HISTORIC AND DESIGN REVIEW COMMISSION

June 16, 2021

HDRC CASE NO: 2021-179
ADDRESS: 506 E PARK AVE
LEGAL DESCRIPTION: NCB 397 BLK 28 LOT 3 & E 1-2 OF 2
ZONING: RM-4, H
CITY COUNCIL DIST.: 1
DISTRICT: Tobin Hill Historic District
APPLICANT: Erin Camp/CAMP ERIN & COPPOLA KEVIN
OWNER: Erin Camp/CAMP ERIN & COPPOLA KEVIN
TYPE OF WORK: Driveway and front walkway modifications
APPLICATION RECEIVED: April 05, 2021
60-DAY REVIEW: Not applicable due to City Council Emergency Orders
CASE MANAGER: Rachel Rettaliata

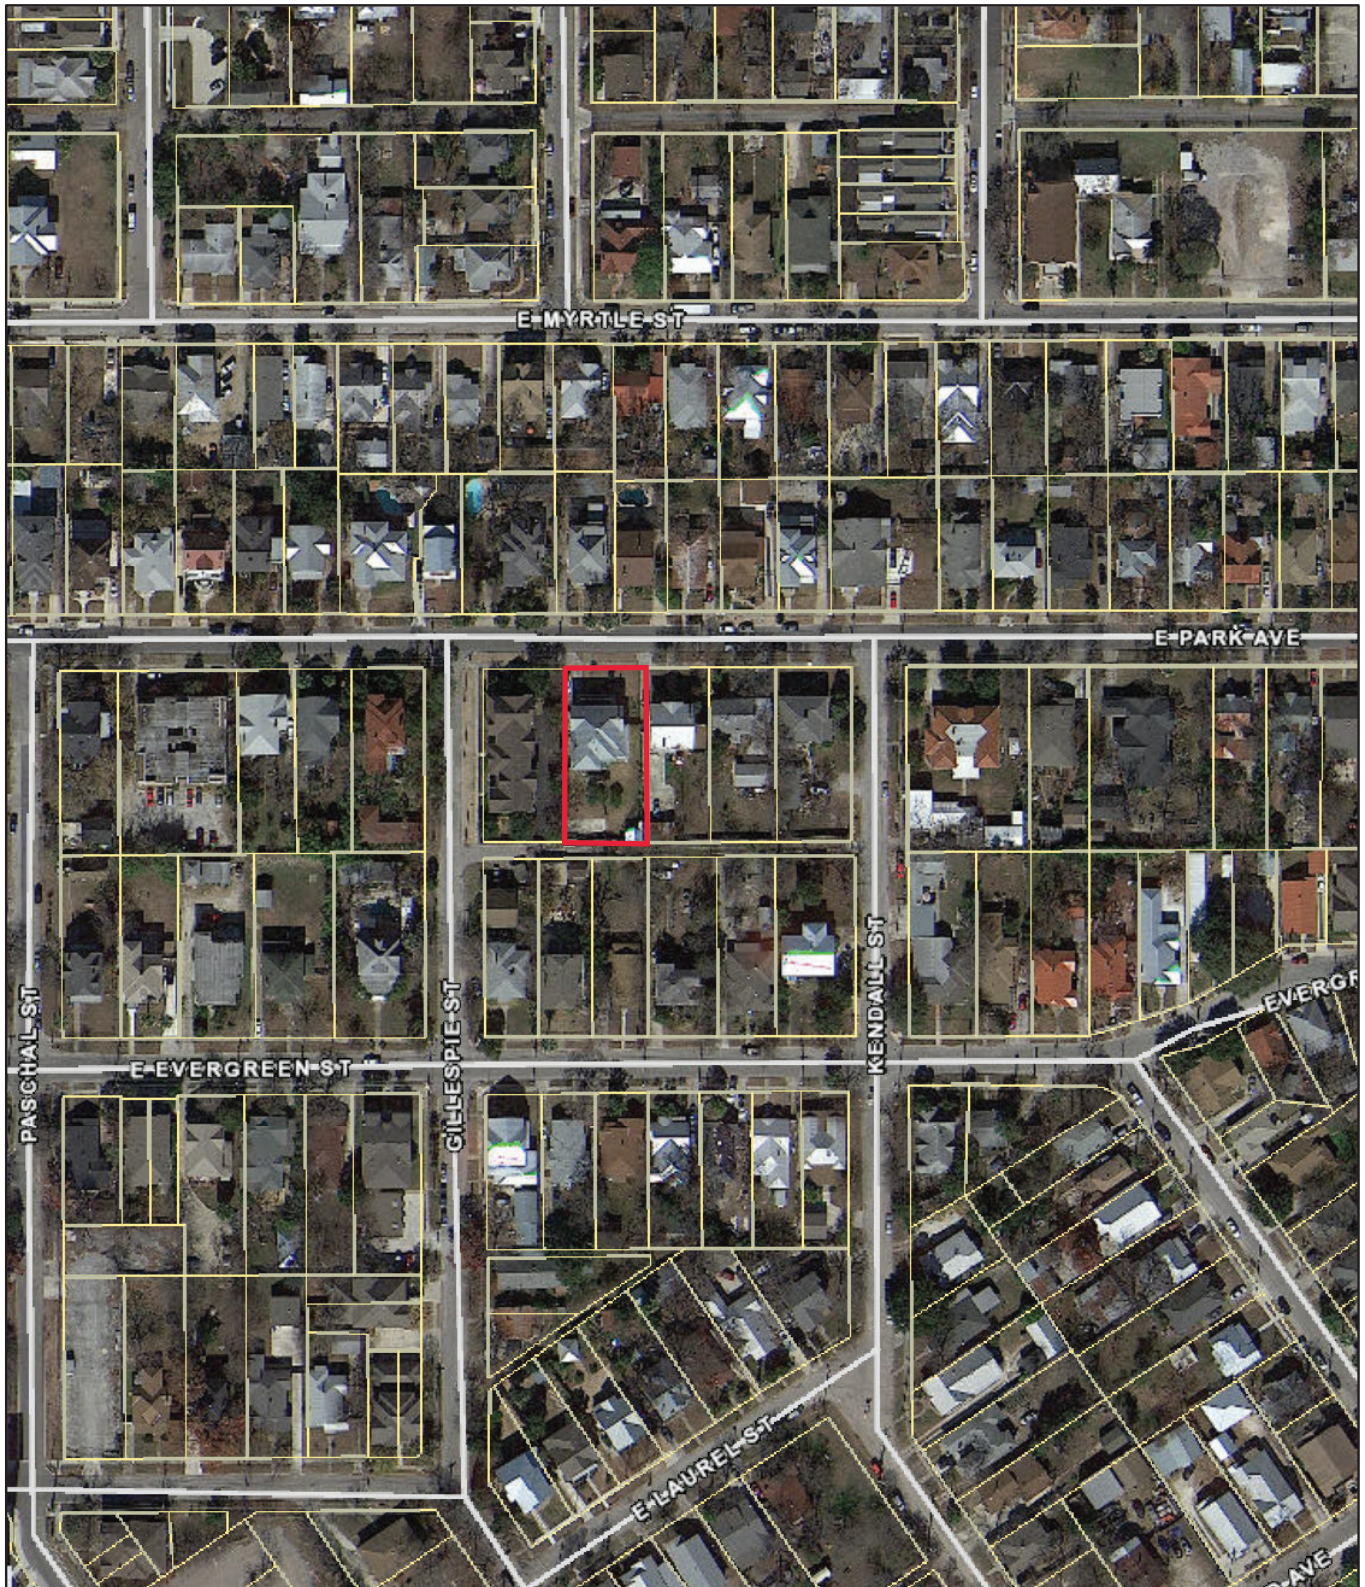
- d. **FRONT WALKWAY REPLACEMENT** – The applicant has proposed to replace the existing brick front walkway with rectangular concrete pavers. Guideline 5.A.i for Site Elements states that historic sidewalk and walkway paving materials—often brick or concrete—should be retained and repaired in place. According to Guideline 5.A.ii for Site Elements, when replacing those portions of sidewalks or walkways that are deteriorated beyond repair, every effort should be made to match existing sidewalk color and material. Guideline 5.A.iii states that replacement of walkways should follow the historic alignment, configuration, and width of walkways. Alter historic width or alignment only where absolutely necessary to accommodate the preservation of a significant tree. While properties immediately adjacent to 506 E Park also feature brick front walkways, the property may have originally featured a fully concrete front walkway. Staff finds the proposal inconsistent with the Guidelines. In-kind front walkway replacement or replacement with a fully concrete front walkway in the same footprint as existing is appropriate.

Item 2, staff does not recommend approval of the concrete paver installation based on finding c. Staff recommends that the applicant replaces the concrete pavers installed without approval with a brick or fully concrete walkway to match the previously existing footprint.

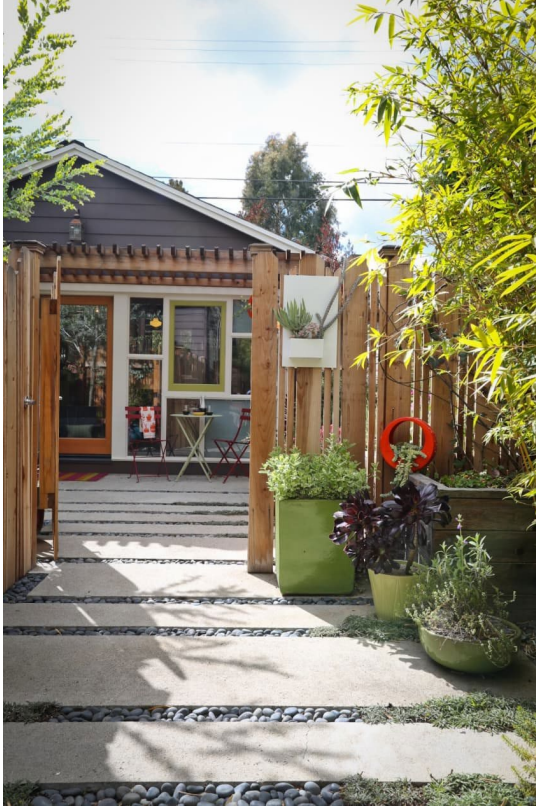
Each paver would be the same width of the front stairs and would be evenly spaced from the other pavers. We would then either put gravel that matches our neighbor's or would attempt to plant grass in between each paver as demonstrated in the first two examples.

Additionally, we would need to demo a portion of the driveway, making it more narrow, so that the pavers can be the appropriate width and match the stairs off the front porch.
